LEE'S SUMMIT MISSOURI

CODE MODIFICATION REQUEST (COMMERCIAL)

BUILDING/STRUCTURE NAME: Lee's Summit Downtown Market Green Street

RESUBMITTAL UPDATE REQUEST: After the previously accepted update to this submittal request, City and Design Team are suggesting an optional method due to the prohibitive cost of extending the countertop to the remainder of the inside area panels. The proposal in this request **would increase the height of the remainder of the inside panels** that do not have a countertop by adding a 6-inch height frameless glass panel system on top of the existing 36-inch height framing system providing the 42-inch code height requirement. The attached exhibit shows these extended areas. Some of this height extension occurs where the drop height is less than 30 inches, however, we are still showing this frameless glass panel for the remainder of the rail system along lengths without the counter. Please refer to attached exhibits 11 – 14 for additional clarification drawings depicting the glass panel extensions. We have also attached a compilation of comments from the inspections and code review process as well as suggestions after the INITIAL code review from staff on r

Resubmittal Exhibit 13

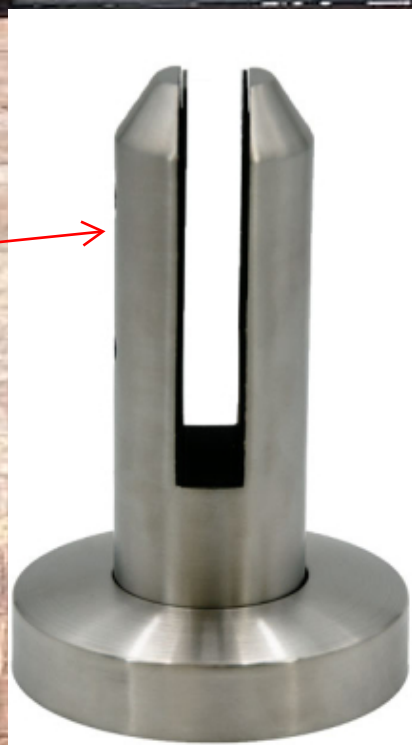
Existing Counter along entire edge

Extend height with glass panel on this entire edge

Frameless Fence clamp to be mounted to top of rail system. Glass inserted into clamp.

DESIGN SOLUTION:
VERTICAL ADDITION TO SITE WALL, IN LOCATIONS THAT DO NOT HAVE THE DRINK RAIL/COUNTERTOP, USING SURFACE MOUNTED GLASS RAILING POSTS TO REACH THE REQUIRED 42"+ GUARDRAIL HEIGHT.

GLASS:
1/2" TEMPERED OR LAMINATED GLASS, ROUNDED EDGES AND CORNERS AS NOTED ON NEXT PAGE.
